R003 - DRAFT SEQUENCE - NOT INSTALLATION APPROVAL

Depth and sealing / review correction

05 / Install only the released material detail

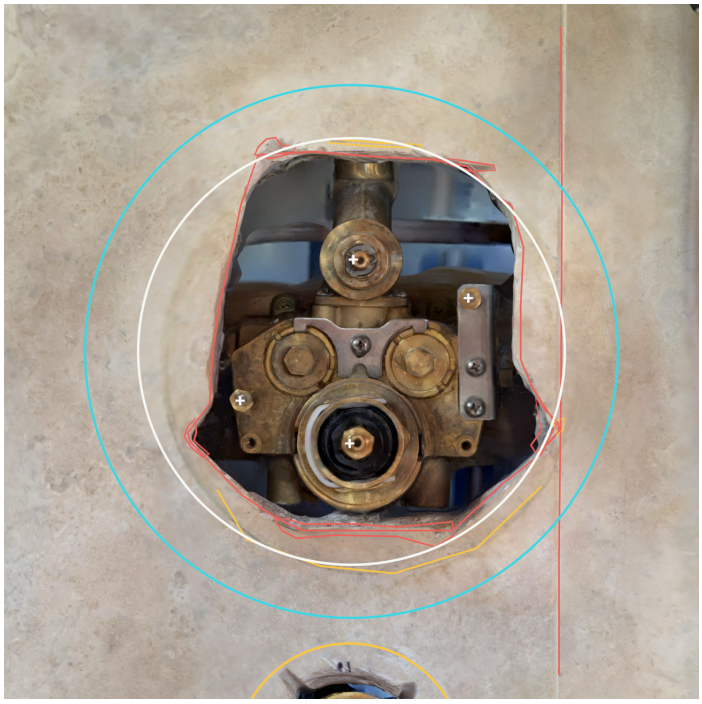
The current seated-cover trial has solid intersections and is rejected. No selected mortar, backing, sealant, finish or cure schedule exists. Do not install from this draft.

Control depth / diagnostic follow-up

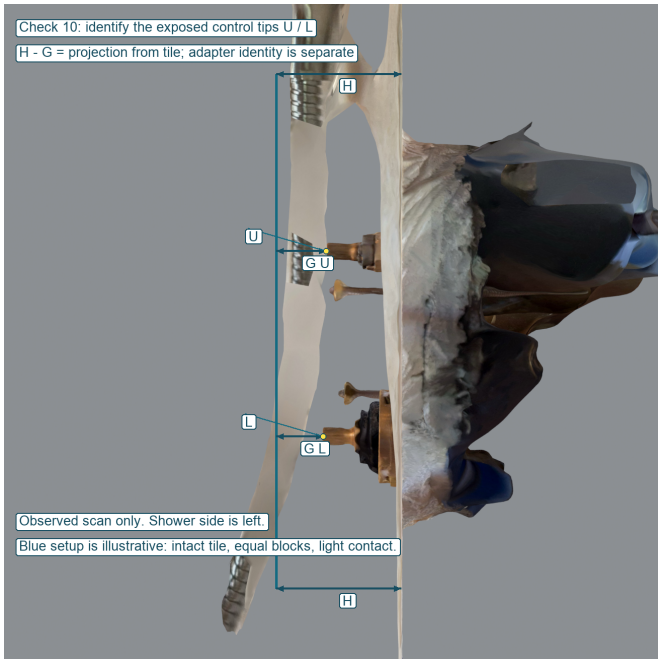
The user confirms excessive stud projection and reports rear bolt contact with wood. Trim studs thread into the valve; they do not need wood anchorage. Identify the same rear fasteners, framing/blocking and usable travel before selecting a remedy.

K-2973-KS specification p3: the labeled upper bare-tip and finished-wall dimensions imply a nominal upper-tip interval -6.3 to 27.0 mm from tile. Current comparison: 32.0 mm (conditional scan tip; identity and physical scale unverified). This is outside nominal interval if same bare tip. It is not a valve-relocation target.

Check 10 identifies the as-found tips/adapters and records block height H and both underside-to-tip gaps. H - G gives signed projection. The installer separately checks the plaster guard or documented axis datum. The 7/16-inch trim-stud limit does not apply to control stems.

Correct adapter and screw lengths must permit handle engagement and full cover/bonnet seating. An added backing plate changes that relationship again. Internal valve seals contain supply water; improper trim seating concerns external shower-water entry. Test these separately after the complete assembly is resolved.
